Rezaul Apparels (Pvt.) Ltd.

19th December 2017

Observations

Roof Layout

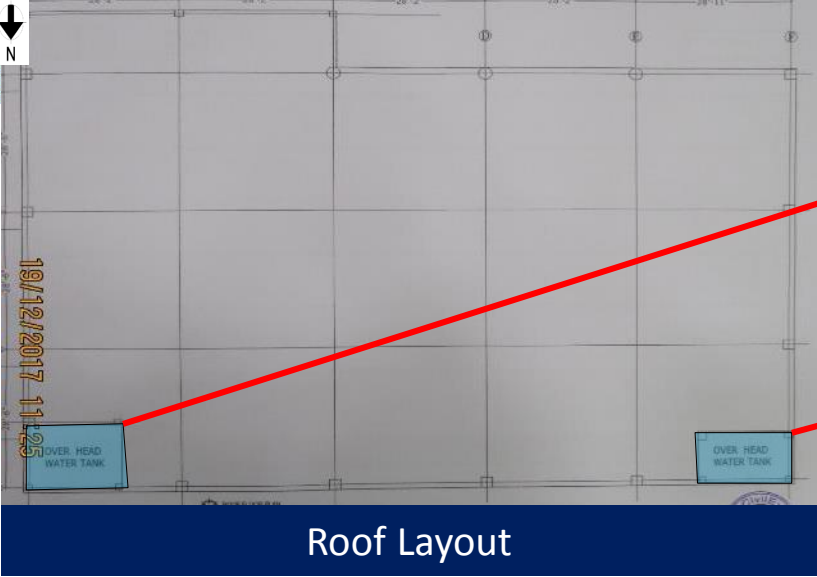
Cursory calculation indicates that highlighted columns appear to be stressed above normal design limits due to over head water tank, brick wall of toilet area and large grid dimension. Factory engineer need to check column stress and a Detail Engineering Assessment (DEA) must be carried out and factory should take necessary action according to report.

Water tank
(4.8mx3.9mx1m)

Typical floor layout

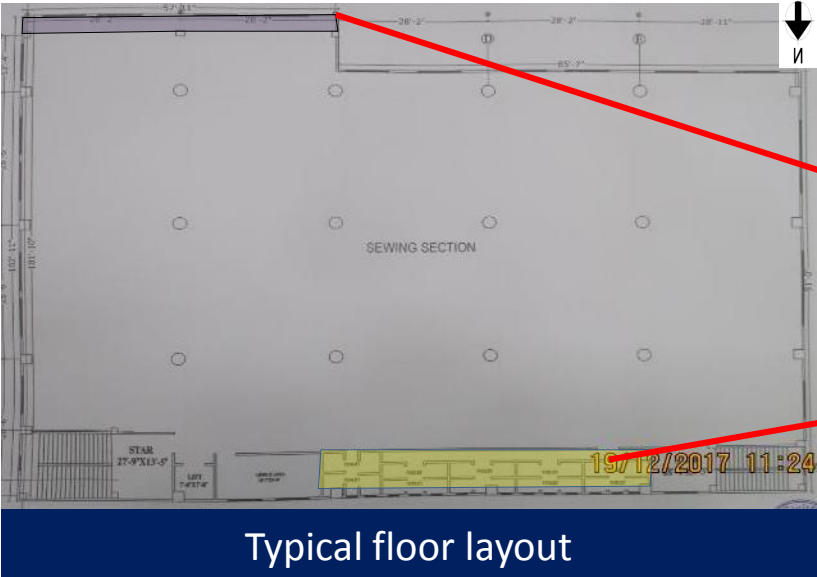
Water tank
(4.9mx2.4mx1m)

1.3m wide cantilever

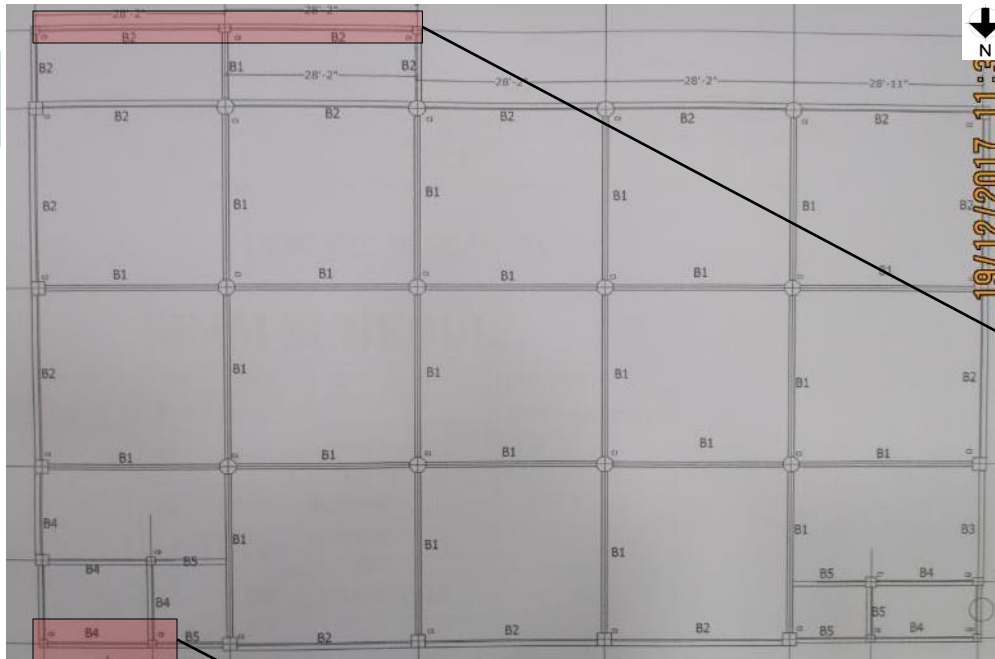
125mm built-up and
125mm thick outer brick
wall on toilet area

Long section of B-2 type mentioned in beam schedule

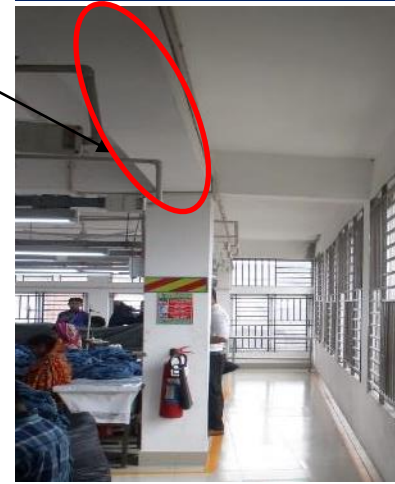
Uniform beam was found instead of tapered beam on south side cantilever part

Beam schedule for B-4 type where depth was shown 20inch (500mm)

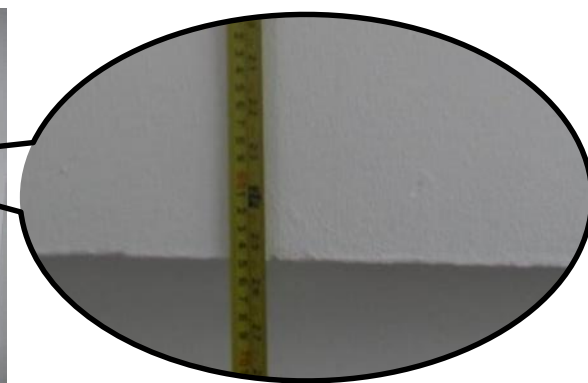
B-4 type beam on staircase was measured 625mm instead of 500mm

Typical slab plan with beam layout

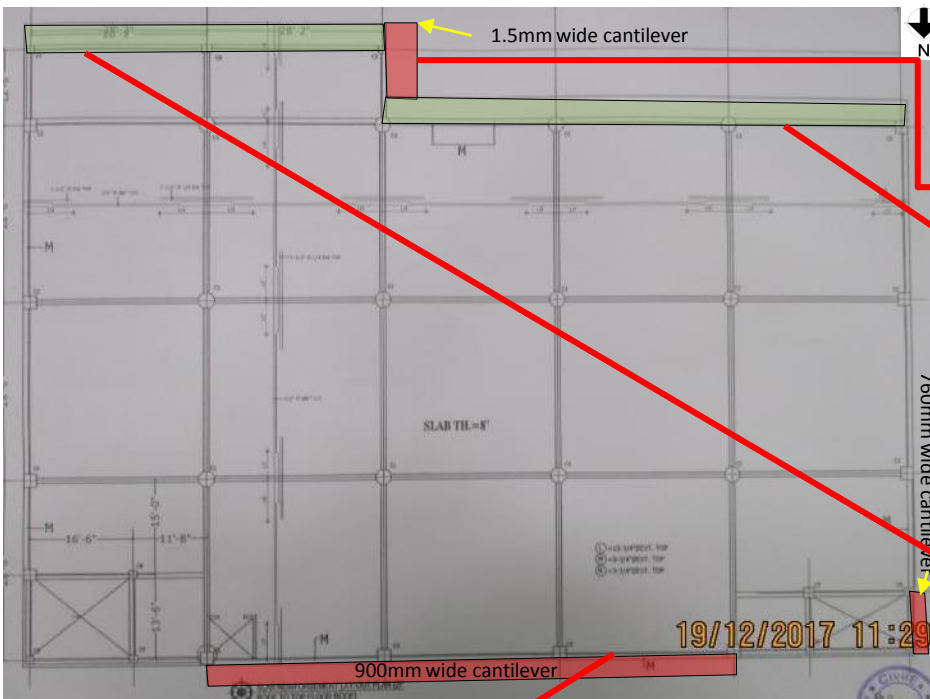
The marked cantilever on south side was not mentioned in as built drawing

Both uniformed and tapered beams were found on south side however the beams were not mentioned in drawing

In north side cantilever portion some toilets were found which were not shown in as-built drawing.

Core wall layout in typical column layout

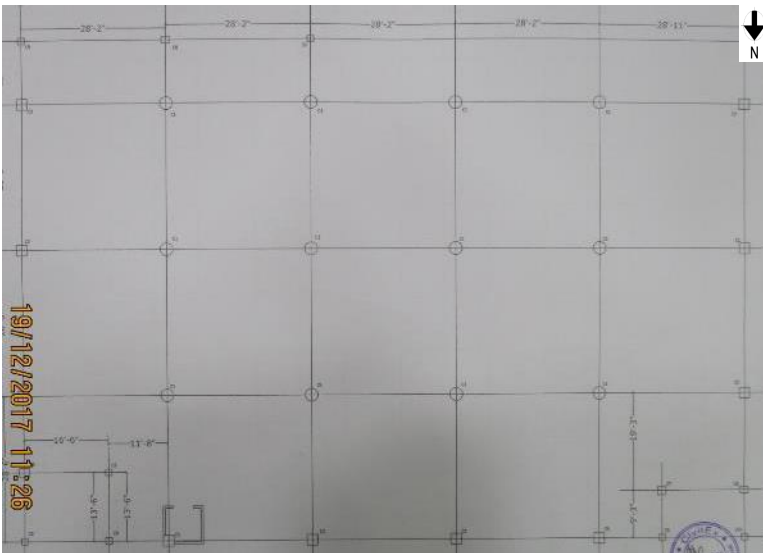
No core wall was found around the lift, only L-shaped column found

Cross section of the building

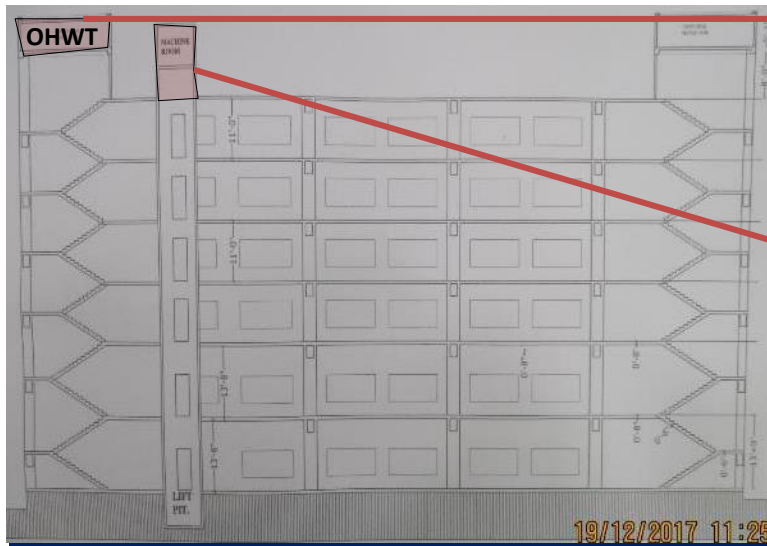
Height of the lift machine room was measured 6.5m instead of 4m. Also, the over head water tank height was measured 1m in place of 1.6m
